In the Matter of)
Pa'ina Hawaii, LLC)
Material License Application)
_____)

Docket No. 30-36974-ML
ASLBP No. 06-843-01-ML

INTERVENOR CONCERNED CITIZENS OF HONOLULU'S
APPLICATION FOR STAY OF NRC STAFF'S ISSUANCE OF
LICENSE FOR POSSESSION AND USE OF BYPRODUCT MATERIAL

Tsunami Evacuation Maps from Ewa Beach to Airport, and from Airport to Waikiki (shaded areas indicate potential inundation zones that need to be evacuated horizontally or vertically in solid structures)

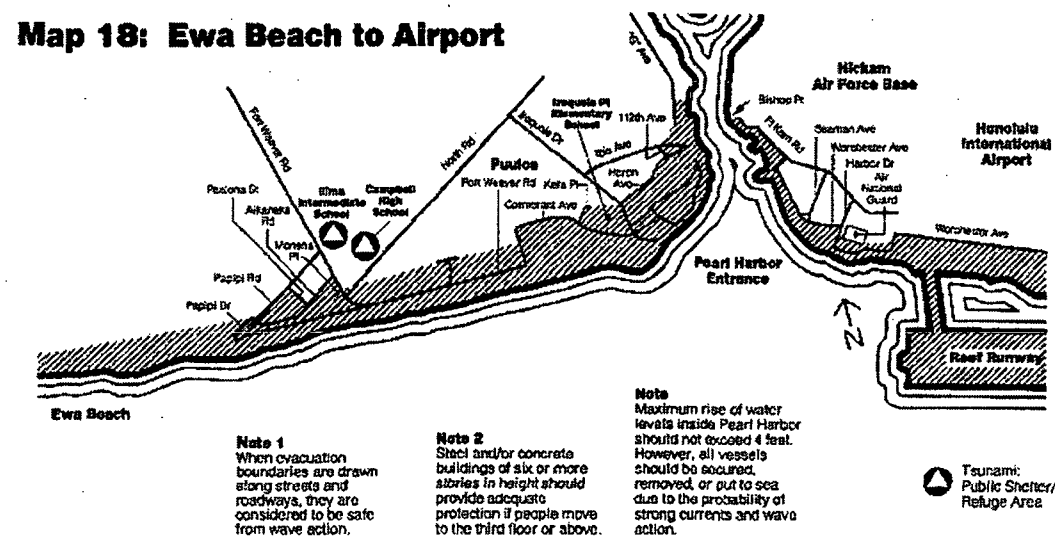
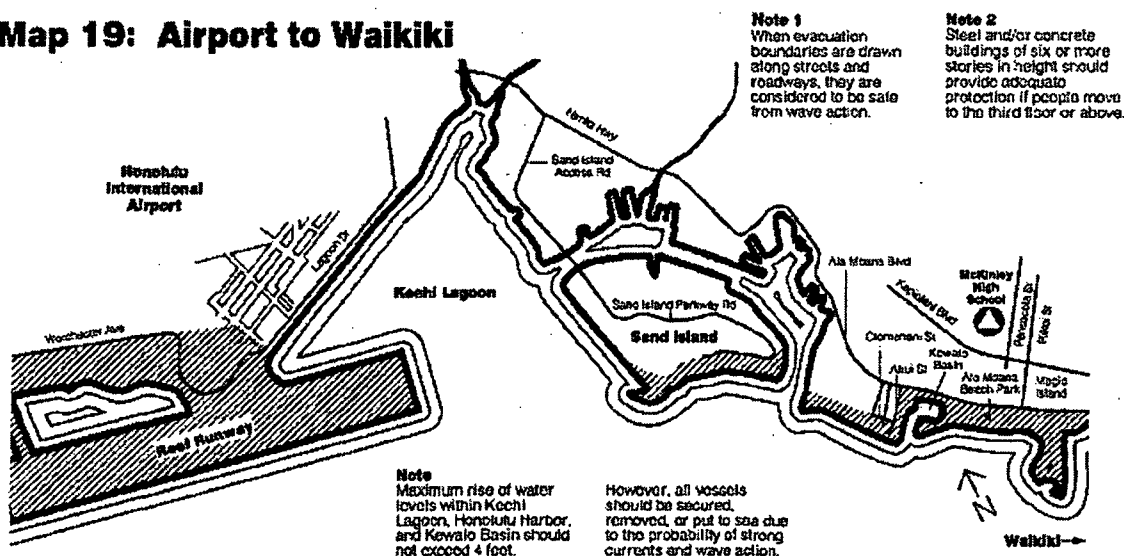
Map 19, provided below, indicates that the tsunami evacuation zone currently extends to the 'ewa (west) side of the last street on Lagoon Drive. Because Palekona Street is the last street on Lagoon Drive, and the proposed Irradiator site is on the 'ewa side of Palekona Street, the proposed Irradiator site is within the tsunami zone. Map 18 and 19 also show that the entire reef runway is within the tsunami zone.

Tsunami Evacuation Limits – The EA and the CNWRA Report both fail to assess or even mention the fact that the proposed Irradiator site is in a tsunami evacuation zone, based on the Civil Defense maps. Also, the CNWRA Report incorrectly states that the O'ahu Civil Defense Agency tsunami flood maps (2006) show the Honolulu International Airport above the tsunami evacuation zone. The Civil Defense maps in fact show that the reef runway and some peripheral airport facilities are within the zone of potential tsunami inundation.

Figure 3. Airport Diagram Honolulu International Airport

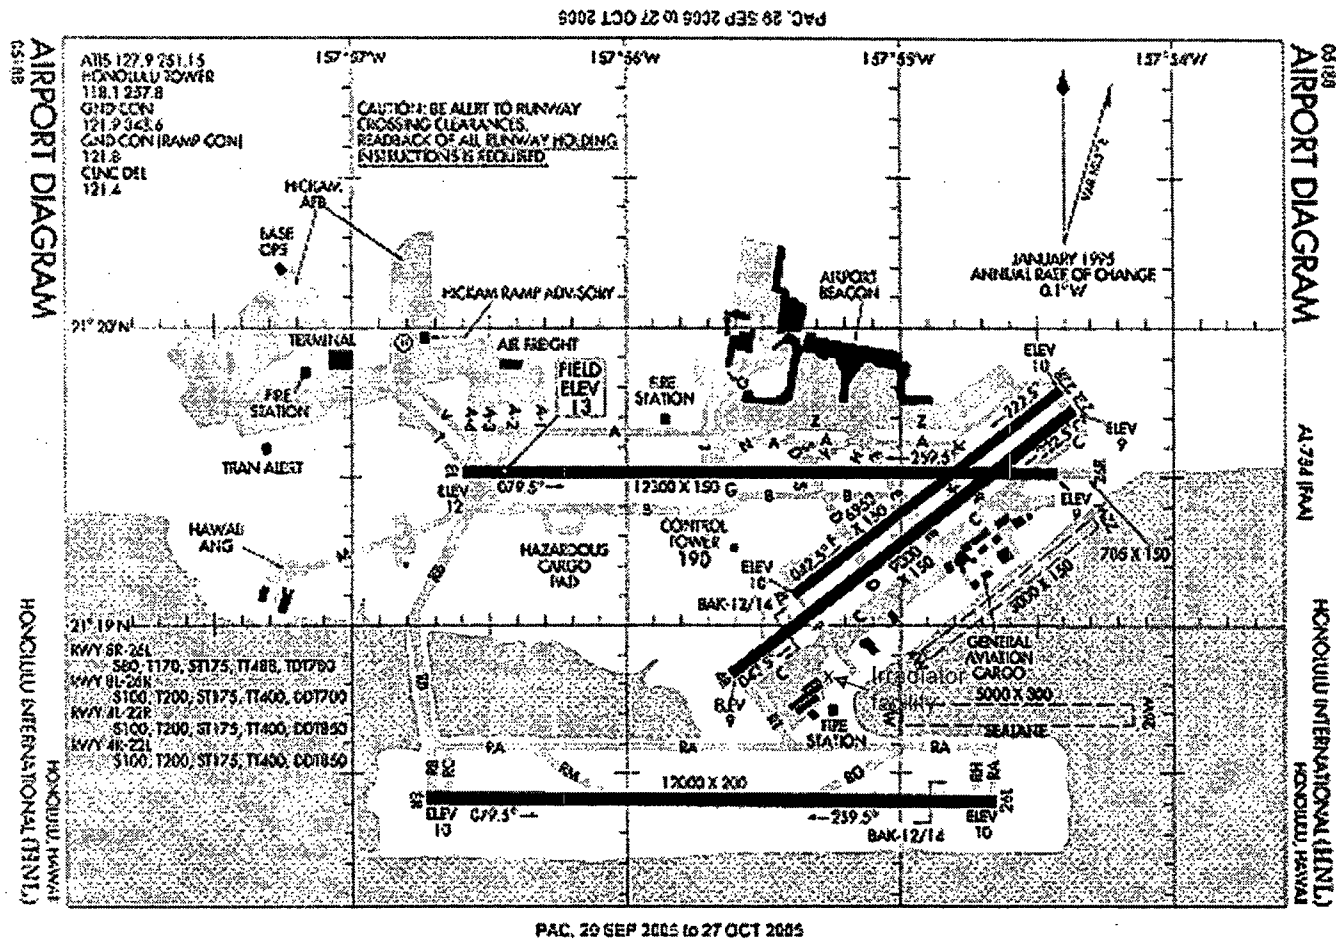
As seen in Fig. 3, the proposed facility is located extremely close to and lies between the runways (4R,22L) and (8R,26L), the reef runway. It is approximately $\frac{1}{4}$ mile from each runway and a little more than $\frac{1}{2}$ mile from the major runway (8L,26R). Table 7 lists the distances of the proposed facility from the center of each of the four runways. The conditional probability distributions are probability estimates in one square mile blocks. That is, given a crash, the conditional probabilities provide the probability that the crash takes place in an area of one square mile. As seen in Table 7, the centers of all runways are within one mile of the proposed facility.

Figure 5. Impact of B767 with steel structure at 100 mph.

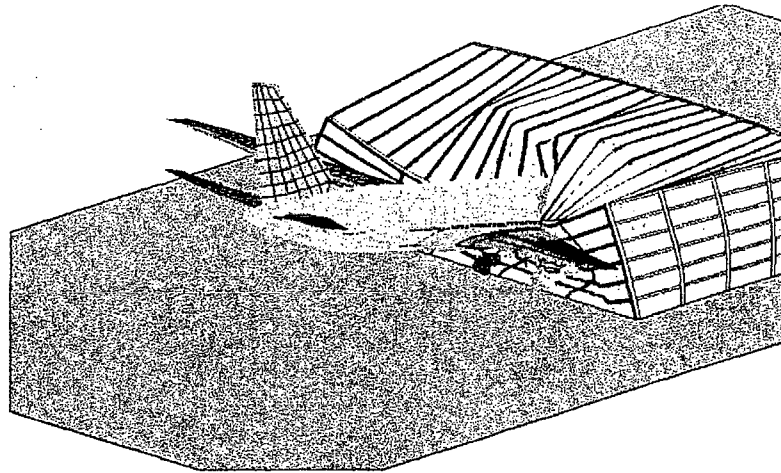
The aircraft was assumed to impact the structure head-on while traveling on the ground at a speed of 100 mph.² The “flight path” was assumed to be parallel to the ground and perpendicular to the rear façade of the structure. As depicted in Figure 5, the calculations indicated that the aircraft will crash through the columns and girders of the building. Impact of the structure at any angle would produce similar results.

Because the building was modeled with a toughness that could not be achieved in practice, this simulation results in acute bending of the columns and the girders, visible in Figure 5. Under actual conditions, many of the columns and girders would fracture or be torn off the connections. Debris and fuel would fill the structure, and the fuel would be expected to ignite explosively, causing a massive conflagration. The total damage within the structure would depend on the existing fire load, including the fuel load and the flammable materials within the building. However, the fire is likely to soften all metals, burn all non-metals, and deteriorate the concrete. This could result in a breach of both the source assemblies and the pool, allowing shielding water to escape. The Co-60 sources could also be exposed if extreme temperatures evaporate the pool water or if the force of the impact disperses the source. In addition, all personnel in the building would likely be killed or incapacitated in the event of a crash and conflagration, and Pa'ina Hawaii's proffered emergency procedures would be rendered useless, because no personnel would be there to implement them.
